May 3, 2016

SUBJECT: PIER 4 PHASE 2 RECONFIGURATION
PROJECT NO. 091251
CONTRACT NO. 070136

ADDENDUM NUMBER THREE

CRANE BEAM PANEL TYPE 'R' SECTION P8A

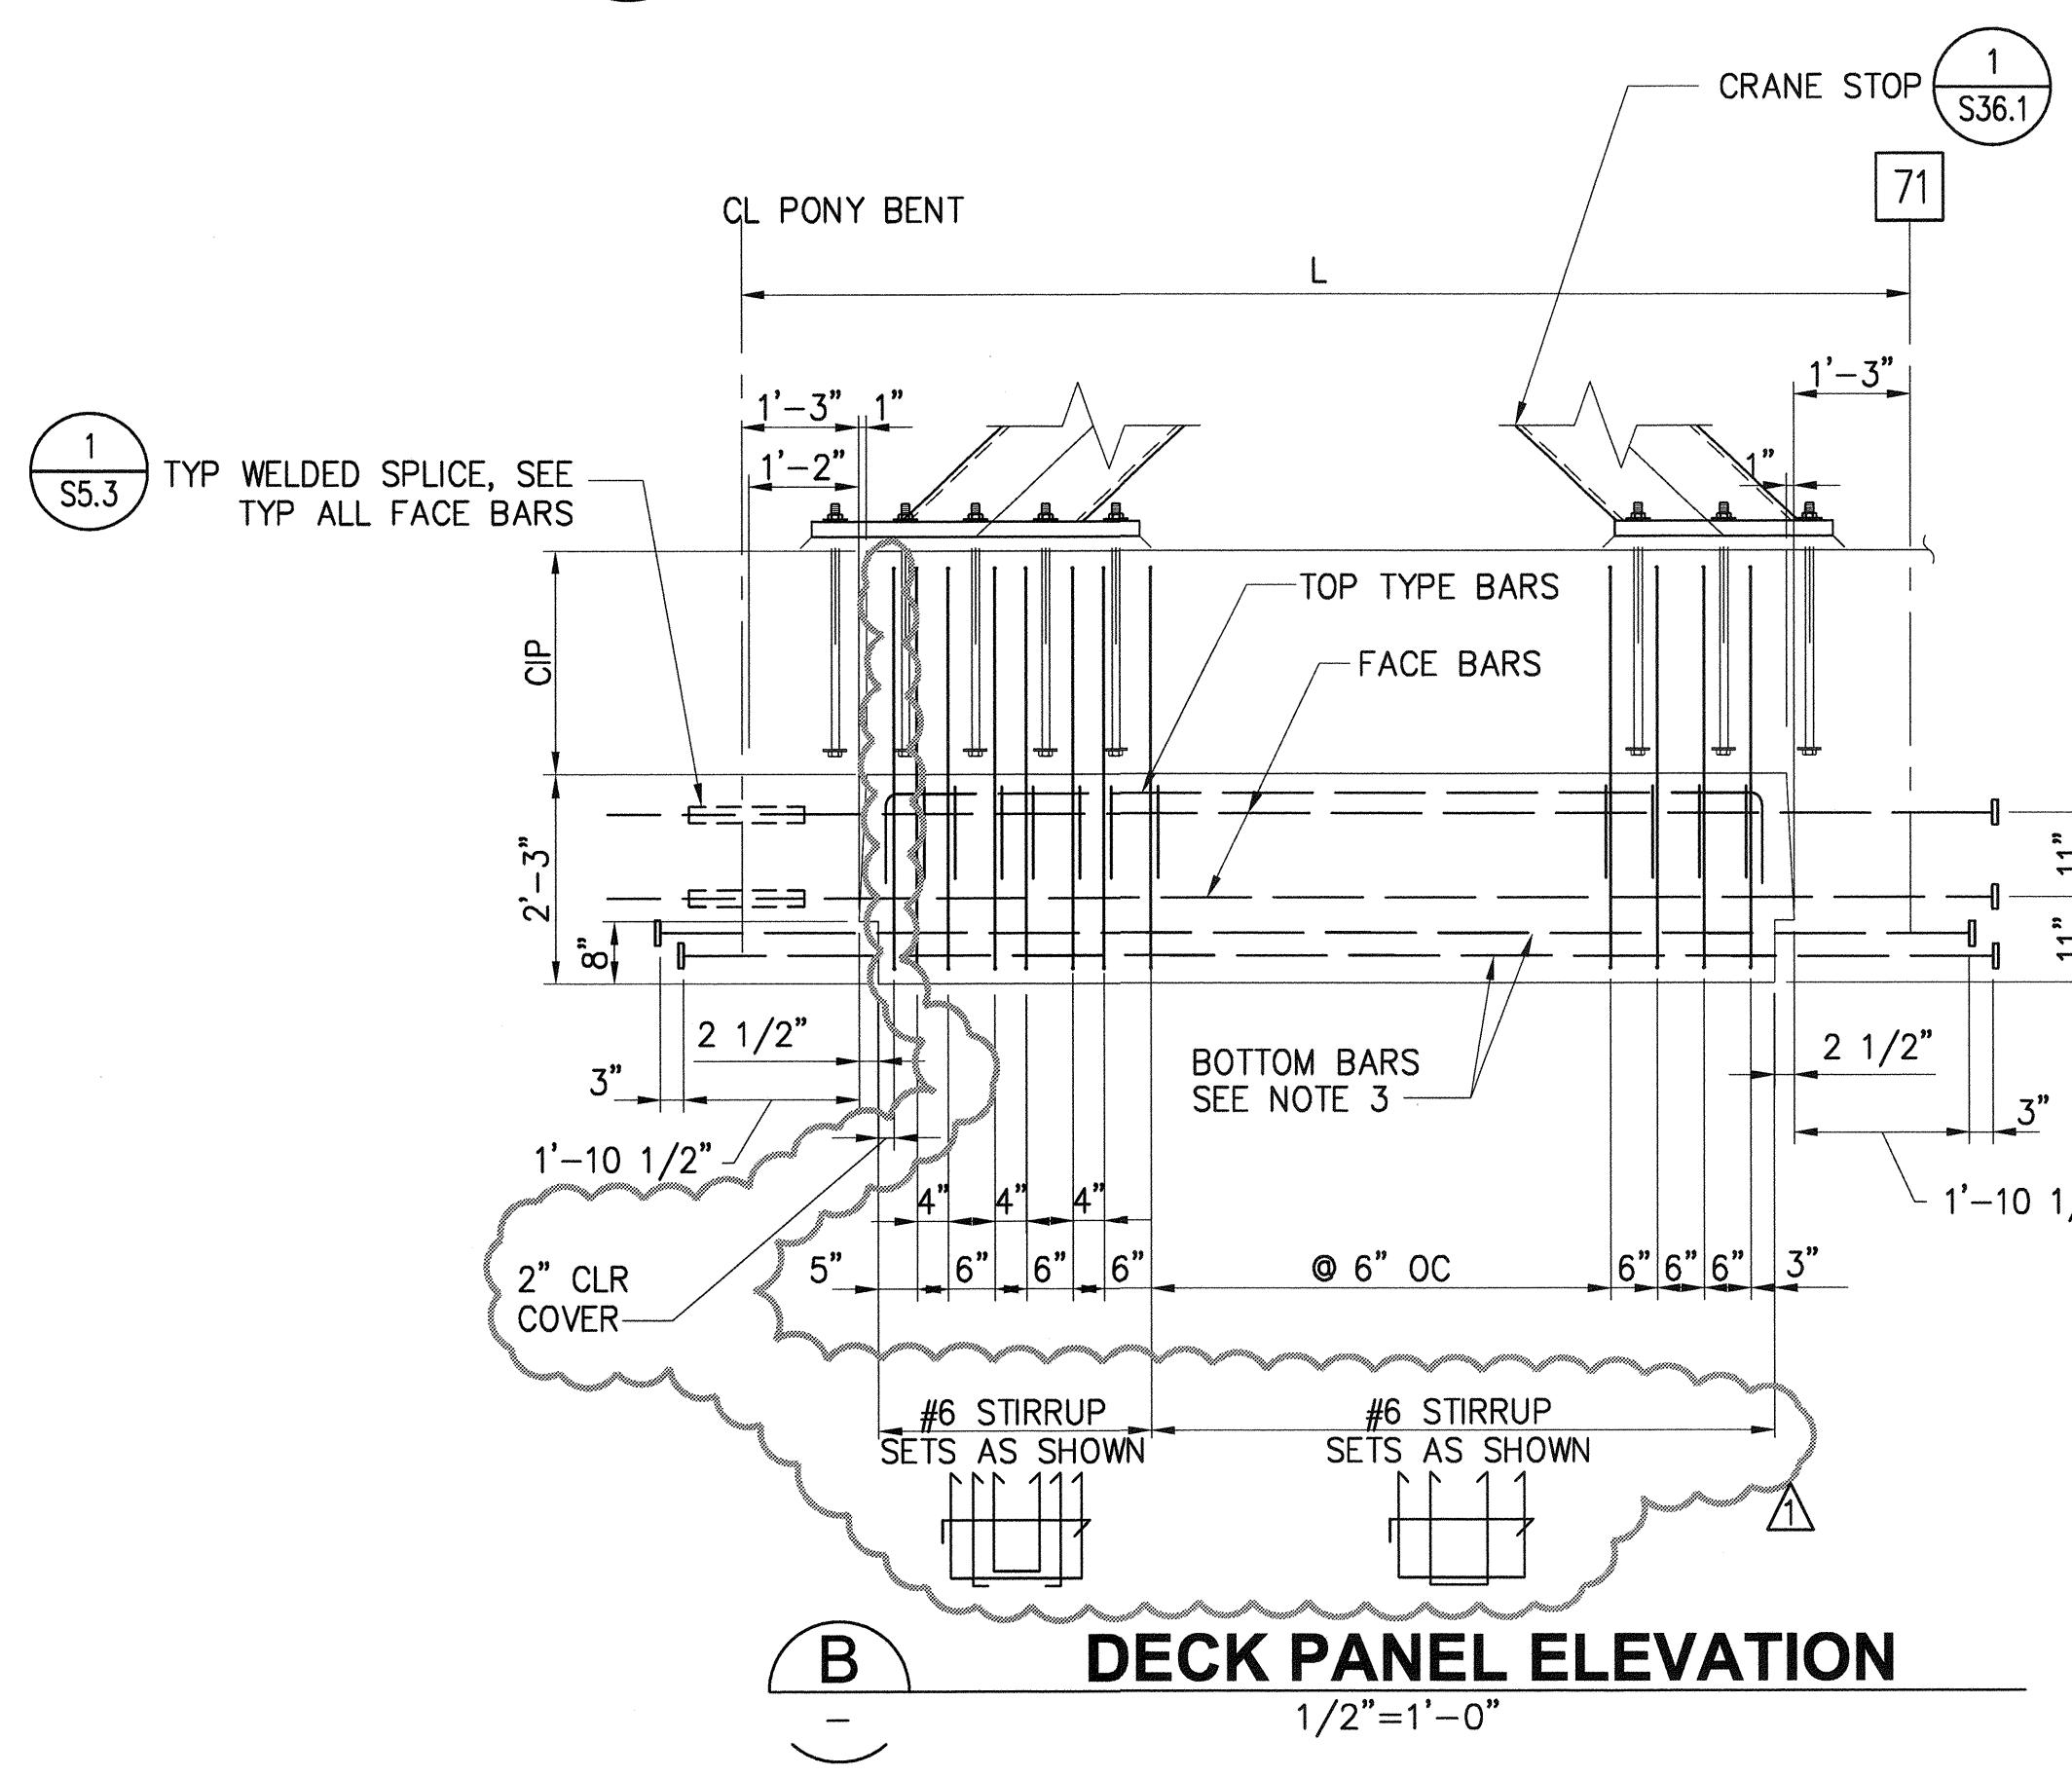
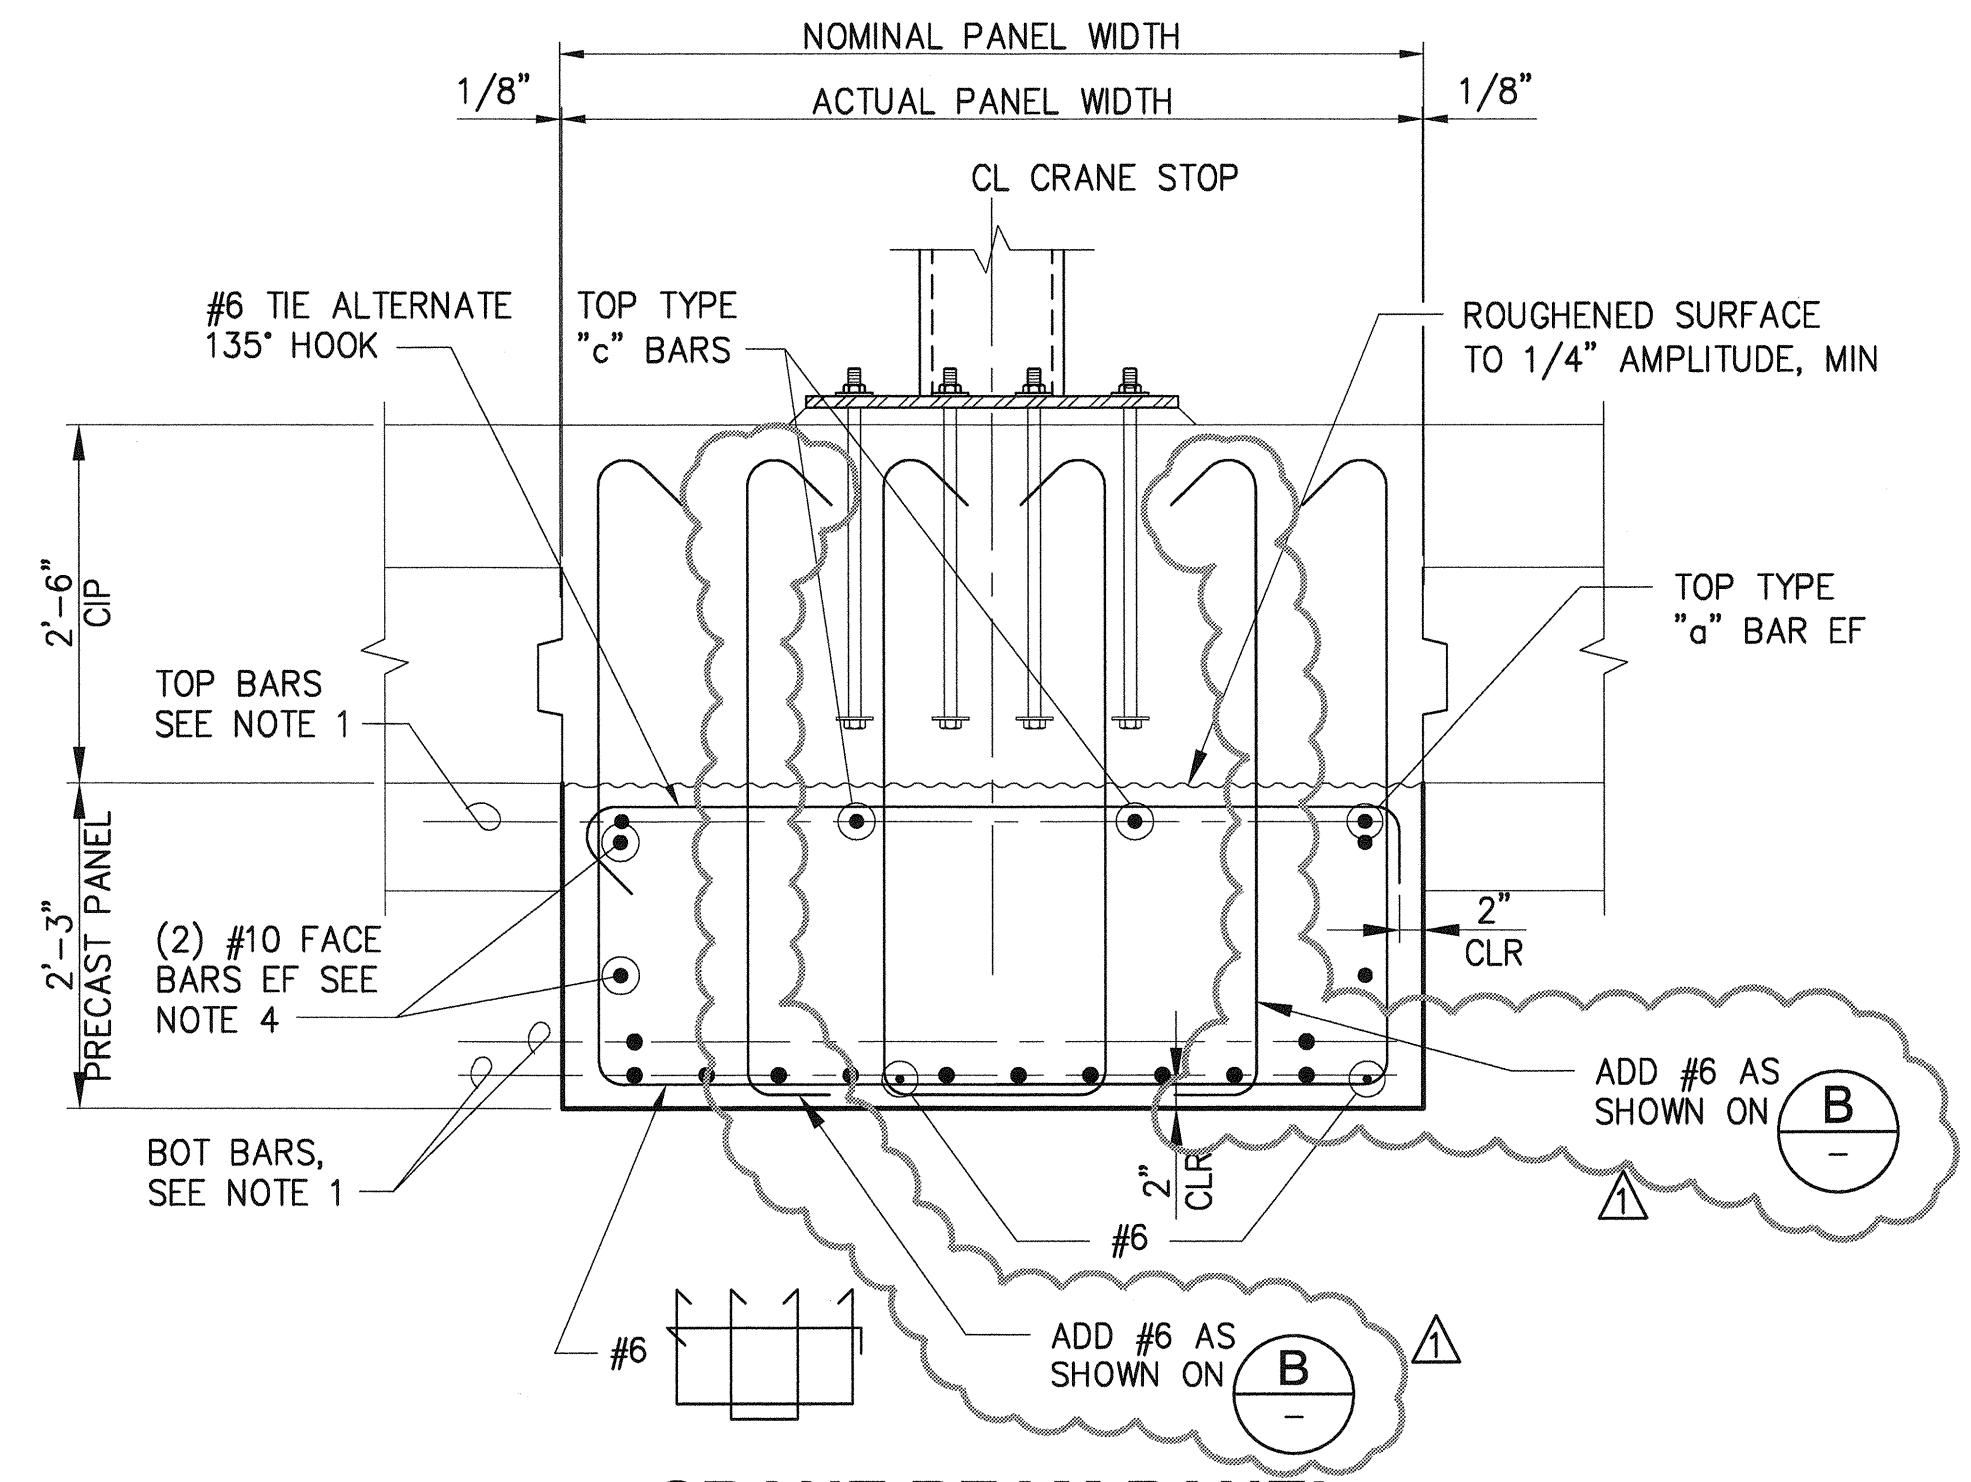
H. DRAWING S27.48 – DECK PANEL DETAILS – SHEET 48 (SHEET 343)

1. **REVISE** Detail A Crane Beam Pan Type ‘R’ Section P8A and Detail B Deck Panel Elevation as denoted. (See Attachment I to this Addendum No. 3)
